Access Compliance Report

Public Rights-of-Way

(Curb Ramps)

Intersection ID: 28277	Main Street: EASTON_GREY_LN	Cross Street: PEMSWOOD_ST	Location: NE
ADA ID: E67EBFABB27F	Ramp Type: BlendTrans2	Initial Pass/Fail: Fail	Overall Compliance: No
Codes/Mitigation Info/Possible Solution		Field Measurements/Component Compliance	
Severity Score: 8.75

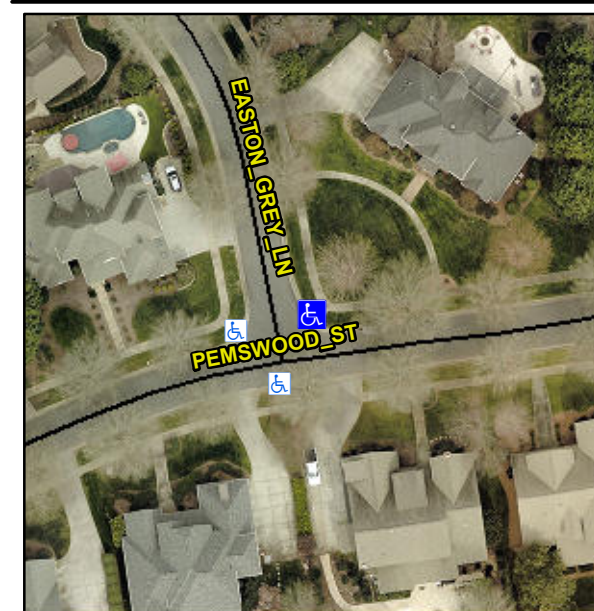
CURB GAP 0.5

Not Found, R304.5.1

Compliance	Description	Data	Compliance	Description	Data
N/A	Ramp Length (in)	156.0	Yes	BlendTrans Slope (%)	3.0
No	Ramp Width (in)	38.0	Yes	BlendTrans XSlope (%)	1.7
N/A	Flare Type LT	N/A	N/A	Flare Type RT	N/A
N/A	Flare Slope LT (%)	N/A	N/A	Flare Slope RT (%)	N/A
N/A	Flare Traversable LT?	N/A	N/A	Flare Traversable RT?	N/A
N/A	Landing Length (in)	N/A	N/A	DWS Provided?	N/A
N/A	Landing Width (in)	N/A	N/A	DWS Contrast?	N/A
N/A	Landing Slope (%)	N/A	N/A	DWS Length (in)	N/A
N/A	Landing X Slope (%)	N/A	N/A	DWS Full Width?	N/A
N/A	Landing Curb? (Y/N)	N/A	N/A	DWS Offset (in)	N/A
N/A	Shared Landing?	N/A			
N/A	Gutter Ponding?	N/A	N/A	Gutter Slope (%)	N/A
N/A	Gutter Lip Ht (in)	N/A	N/A	Gutter X Slope (%)	N/A
N/A	Painted X Walk1?	No	N/A	Painted X Walk2?	No
	X Walk 1 Direction	To W		X Walk 2 Direction	To SE
	X Walk 1 Width (in)	N/A		X Walk 2 Width (in)	N/A
	X Walk 1 Slope (%)	2.8		X Walk 2 Slope (%)	4.2
	X Walk 1 X Slope (%)	3.7		X Walk 2 X Slope (%)	0.1

N/A	Ramp inside XWalk1?	N/A	N/A	Ramp inside XWalk2?	N/A
	Road Slope (%)	2.1		Clear Space?	N/A
	Road X Slope (%)	1.1	N/A	Clear Space to XWalk (in)	N/A
N/A	Any Obstructions?	N/A	N/A	Storm Grate/Utility Hazard?	N/A
	Obstruction Type			Storm Grate/Utility Type	
		N/A			N/A
			Yes	Surface Condition? (G/P)	Good
			No	Curb Slope (%)	9.6

Remove & Replace Curb Ramp With Two New Directional Ramps or Equivalent.
